### City of Cannon Beach Tree Removal Application

**Property Location:** 208 E Monroe St. **Map/Tax Lot Number:** 51029BC01200

**Tree Removal Permit Application Review - 208 E Monroe**

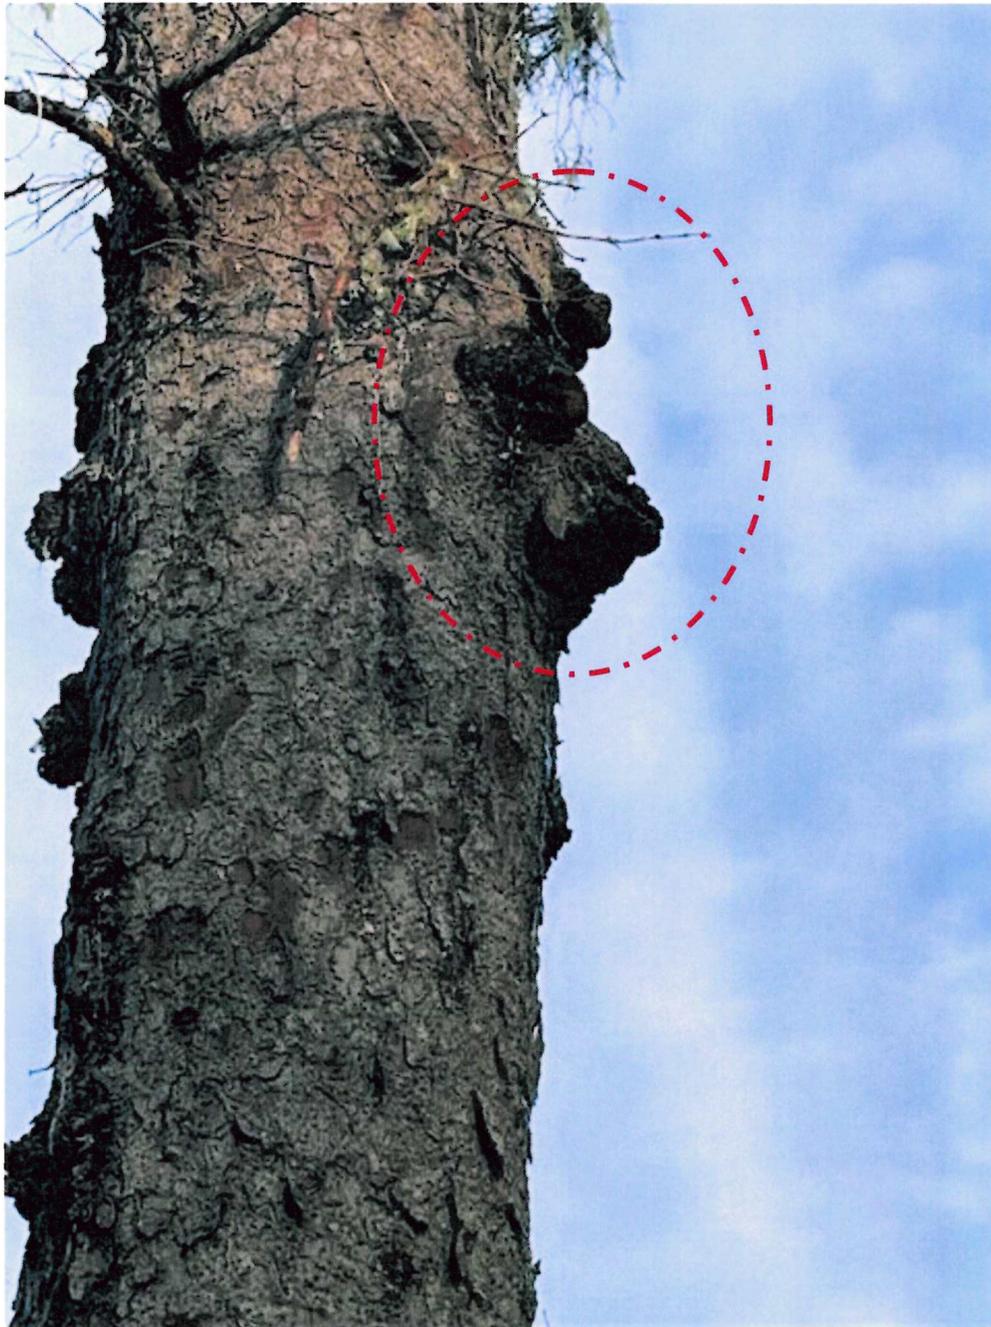
Red Ring Rot conks visible from east side of tree

Sitka spruce to be removed
